REFERENCE	BT_2014_FR16_4_UK
DATE	30 July 2014
SUBJECT	New driveshaft release, 2014 exhaust support fitting update, cockpit sealing
PART	Driveshaft, muffler support and strap, tub and safety harness

Driveshaft V3

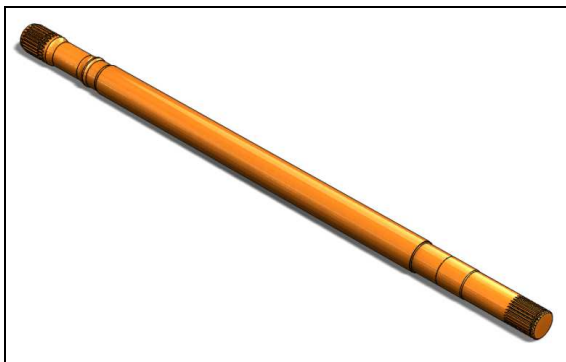
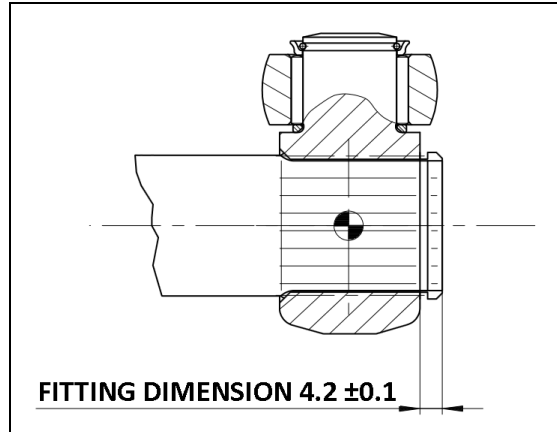
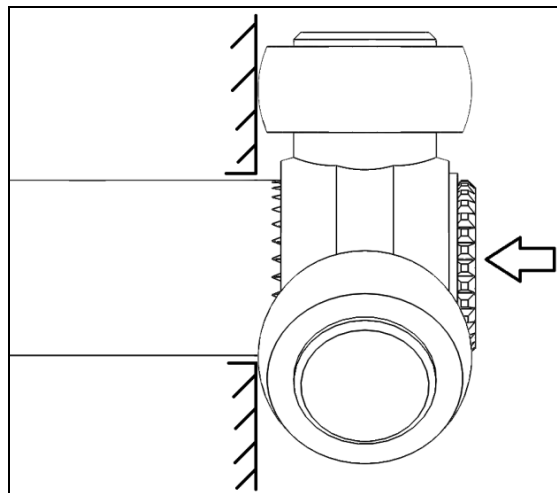
In order to improve the driveshaft lifetime, Signatech has designed a new driveshaft based on a new material, an improved design and a new assembly method.

This new driveshaft needs a specific mounting process using a press to fit the G04-15A003V1 Tripod Joint on the G04-15A001V3 Driveshaft V3

Insert the Tripod Joint at 4.2 mm from the end of the Driveshaft, as shown in the picture below:

Mount the G04-15A005V1 Tripod Circlip SW24 on the Driveshaft. Then, block the Tripod Joint as shown in the picture below and push the Driveshaft to ensure the position of the Tripod Joint: the circlip must be in contact with the Tripod Joint and with the closer groove face from the Driveshaft end.

Driveshaft V3: G04-15A001V3

Both old (G04-15A001V1 & G04-15A001V2) and new (G04-15A001V3) driveshafts are allowed on the car.

Note: The driveshaft V3 is heavier of about 800g compared to the previous V2 version.

2. 2014 exhaust support fitting update

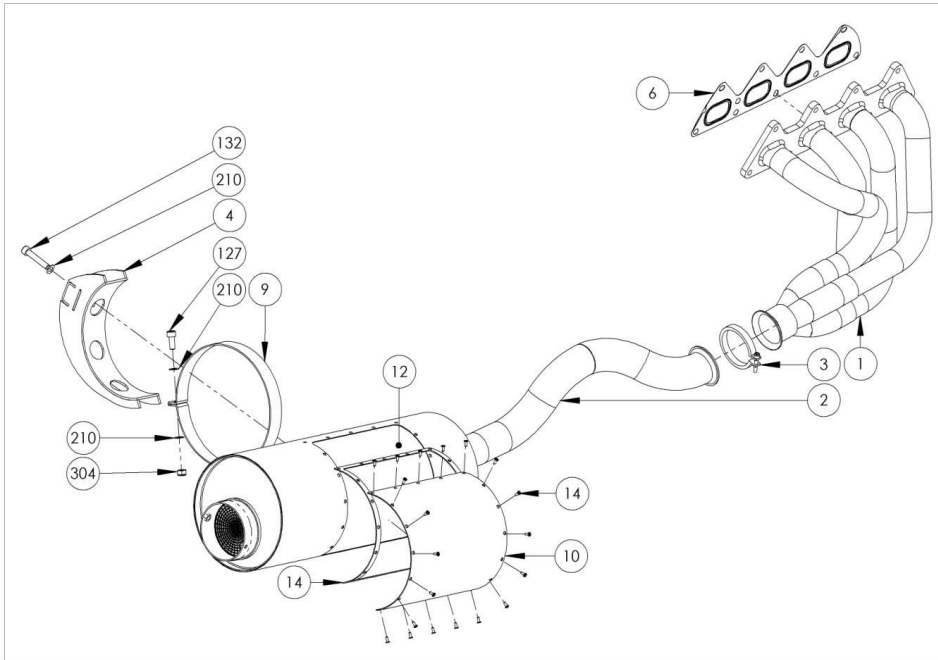
The genuine flat washers Ø8 x 16 (qty 3, identified by the n.210) must now be replaced by **Onduflex washers Ø8 (qty 3, ref G04-21B010V1)** to ensure the fitting of the Muffler Support V2014 (ref G04-06C004V2, n.4) and the Muffler Strap (ref G04-06C009V1, n.9).

Note: these washers, classified in category A of the nomenclature, will be mandatory from August 2014, 11th.

3. Cockpit sealing **MANDATORY FROM AUGUST 2014, 11th**

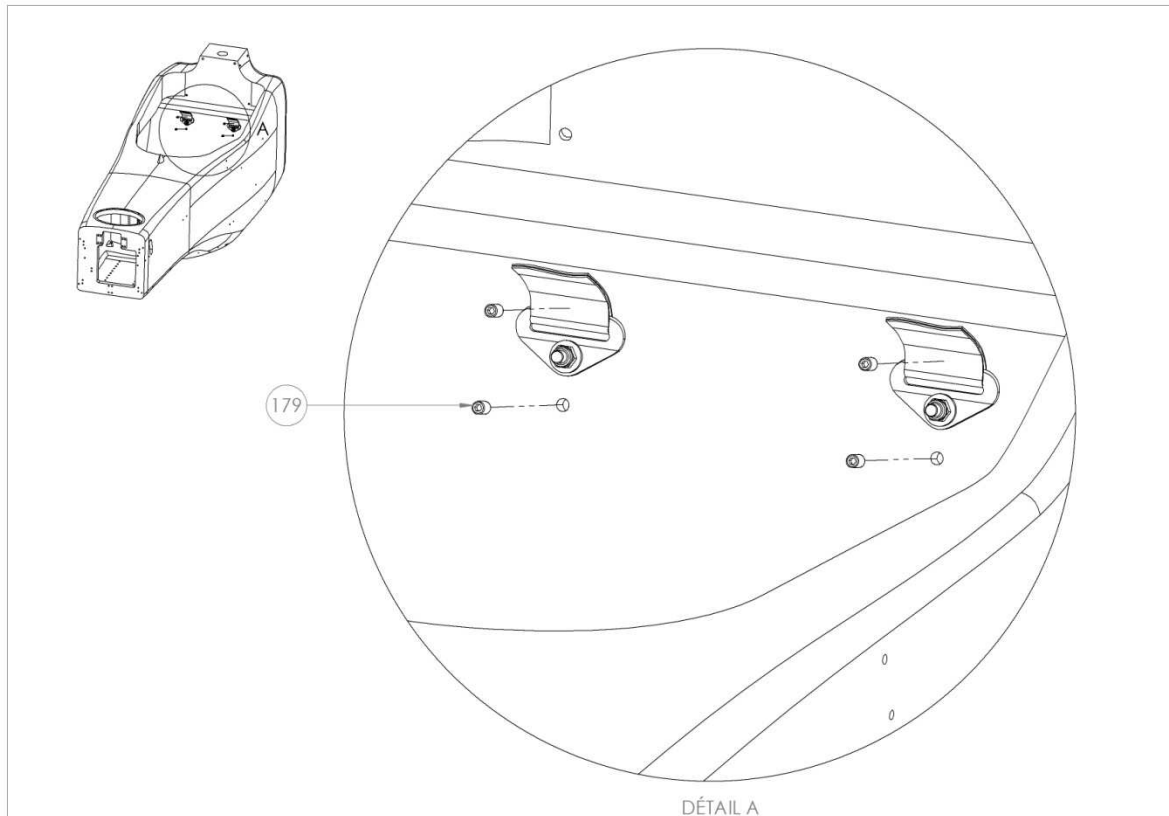
In order to seal the cockpit area from the fuel cell cavity, it is compulsory to mount obstruction screws STHC M8x16 (ref **G04-21A079V1 STHC M8 x 16**) with Loctite 577 in the unused threaded holes of the safety harness (unused holes location depending on your safety harness setup)

Note: this modification will be mandatory from August 2014, 11th.
